PHILADELPHIA ELECTRIC COMPANY'S
LIMERICK PLANT
CONTROL ROOM DESIGN REVIEW
SUPPLEMENTAL REPORT NUMBER 1
FINAL REPORT OF JUNE 1984

OCTOBER 1984

LIMERICK PLANT
CONTROL ROOM DESIGN REVIEW
SUPPLEMENTAL REPORT

Figure 1. Control Room Panels Before Enhancements

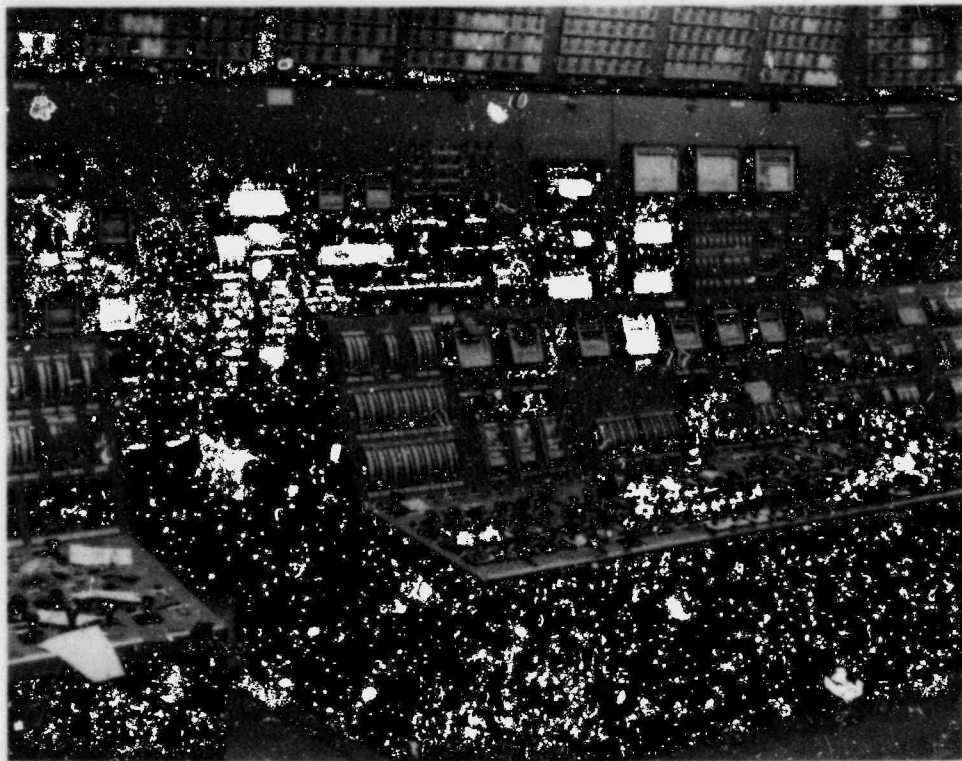
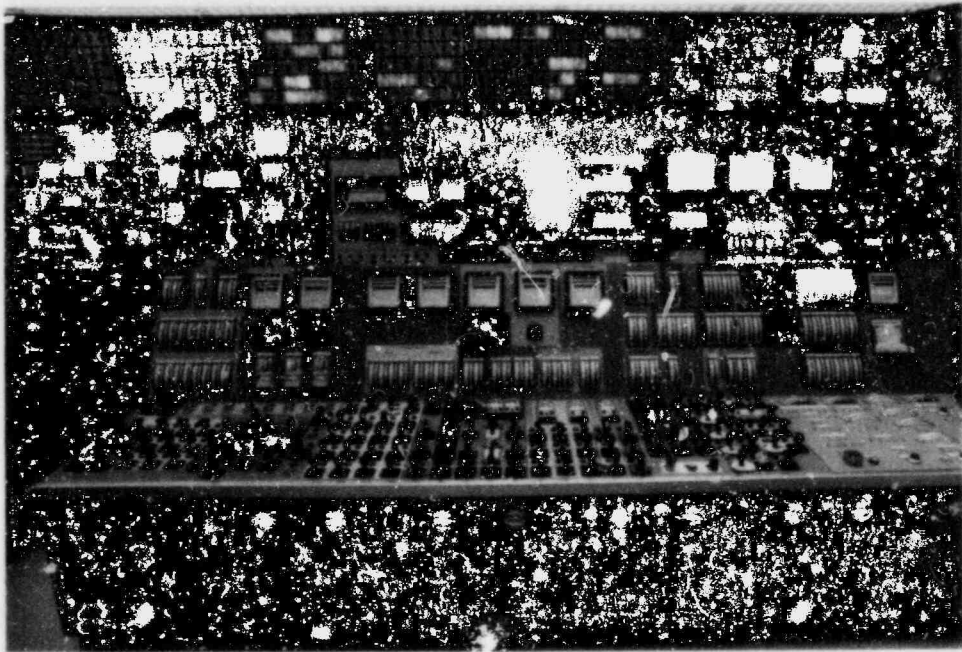
The Final Report discussed, in detail, the types and methods of improvements to the panels. These methods and techniques were used and the actual panel enhancement effort was completed in mid-September 1984. Subsequent refinements to the enhancements are currently ongoing. Figures 1 and 2 show photographs of the control room panels before and after enhancement. Additional improvements will be implemented as dictated by the schedule as indicated on individual HED Assessment sheets.
